Revision "M"

(M) January 7, 1999
Modifications to Firehouse Signal.
S.H.A. No. BW996M82

MDOT - STATE HIGHWAY ADMINISTRATION
Office of Traffic & Safety
TRAFFIC ENGINEERING DESIGN DIVISION
(Traffic Signal Plan)

MD 22 (Churchville Road) at Maitland Street/ Hickory Avenue

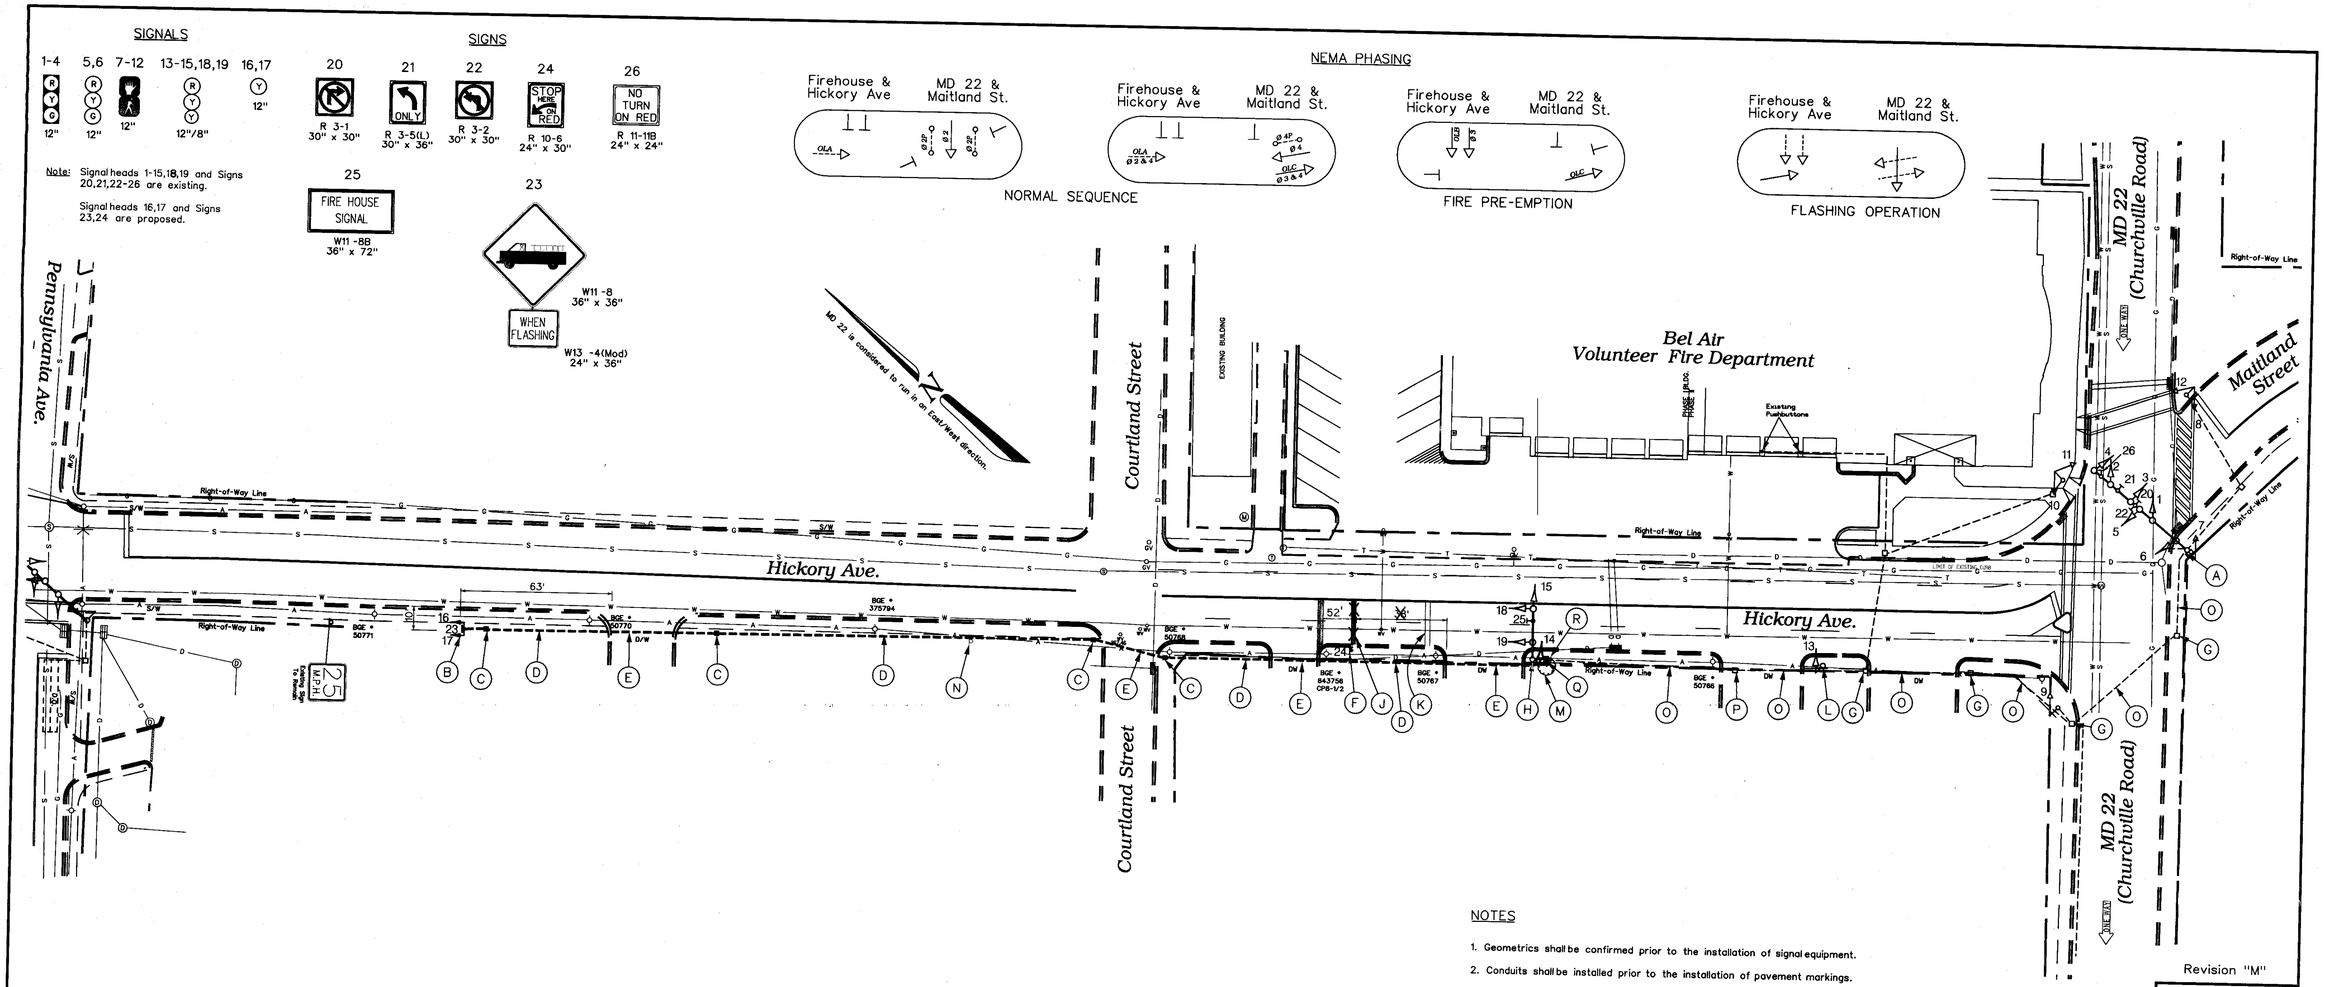
4. Revision 'M' is a revision to the traffic signal built in October 1984 under S.H.A. Contract No.: H-757-501-485.
5. All underground and overhead utilities shown on these plans are schematic and are not to be considered complete. The Contractor shall be responsible for notifying all utility companies prior to construction so, that all utilities may be located in the field. If the Contractor perceives that a conflict between the utilities and the traffic signal equipment will occur, the Contractor shall notify the appropriate Project Engineer immediately.

A. Use existing pole mounted cabinet/controller, and all attached equipment. Install a new two circuit flasher.
B. Install 14 ft. steel pedestal pole on a break away base with signal heads, and signs (Note: one 2 in. PVC conduit bend). Paint using [City of Hagerstown Spec. Green].

C. Install handhole.
D. Install 2 in. polyvinyl chloride [Schedule 80] electrical conduit - trenched.
E. Install 2 in. polyvinyl chloride [Schedule 80] electrical conduit - slotted in roadway.

F. Install ground mounted sign as shown.
G. Use existing handhole.
H. Use existing steel mast arm pole. Pull back all existing cables to nearest handhole, and rerun in existing conduit and new handhole. Adjust traffic signal heads as necessary. Paint using [City of Hagerstown Spec. Green].

J. Install 24 in. wide thermoplastic pavement marking - white for stop line.
K. Remove existing pavement marking by grinding.
L. Paint existing pedestal pole using [City of Hagerstown Spec. Green]..

M. Trim existing tree for singal head visibility.
N. Remove existing fire house warning sign.
O. Use existing conduit.
P. Verify location of existing handhole and adjust to grade as necessary.

Q. Install handhole on existing conduit run.
R. Remove and replace existing sidewalk as necessary.
